Access Compliance Report

Public Rights-of-Way

(Curb Ramps)

Intersection ID: 50615	Main Street: FAWN_LILY	Cross Street: BALSAM_BAY_RD	Location: E
ADA ID: 2CAF38EA08FE	Ramp Type: Perp	Initial Pass/Fail: Fail	Overall Compliance: No
		Severity Score: 22.5	
Codes/Mitigation Info/Possible Solution		Field Measurements/Component Compliance

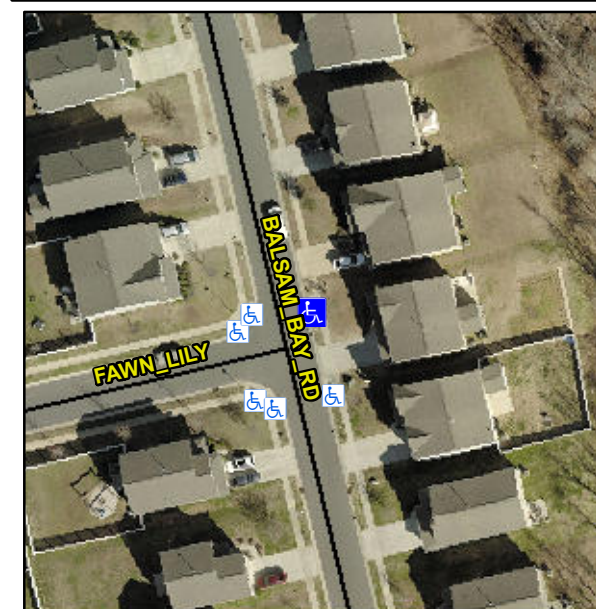
R304.5.1, R304.2.2, R304.5.3

Compliance	Description	Data	Compliance	Description	Data
N/A	Ramp Length (in)	48.0	No	Ramp Slope (%)	9.5
No	Ramp Width (in)	47.5	No	Ramp XSlope (%)	3.3
N/A	Flare Type LT	N/A	N/A	Flare Type RT	N/A
N/A	Flare Slope LT (%)	N/A	N/A	Flare Slope RT (%)	N/A
N/A	Flare Traversable LT?	N/A	N/A	Flare Traversable RT?	N/A
N/A	Landing Length (in)	N/A	N/A	DWS Provided?	N/A
N/A	Landing Width (in)	N/A	N/A	DWS Contrast?	N/A
N/A	Landing Slope (%)	N/A	N/A	DWS Length (in)	N/A
N/A	Landing X Slope (%)	N/A	N/A	DWS Full Width?	N/A
N/A	Landing Curb? (Y/N)	N/A	N/A	DWS Offset (in)	N/A
N/A	Shared Landing?	N/A			
N/A	Gutter Ponding?	N/A	N/A	Gutter Slope (%)	N/A
N/A	Gutter Lip Ht (in)	N/A	N/A	Gutter X Slope (%)	N/A
N/A	Painted X Walk1?	No	N/A	Painted X Walk2?	N/A
	X Walk 1 Direction	To W		X Walk 2 Direction	N/A
N/A	X Walk 1 Width (in)	N/A	N/A	X Walk 2 Width (in)	N/A
	X Walk 1 Slope (%)	2.6		X Walk 2 Slope (%)	N/A
	X Walk 1 X Slope (%)	2.5		X Walk 2 X Slope (%)	N/A

Remove & Replace Entire Ramp.
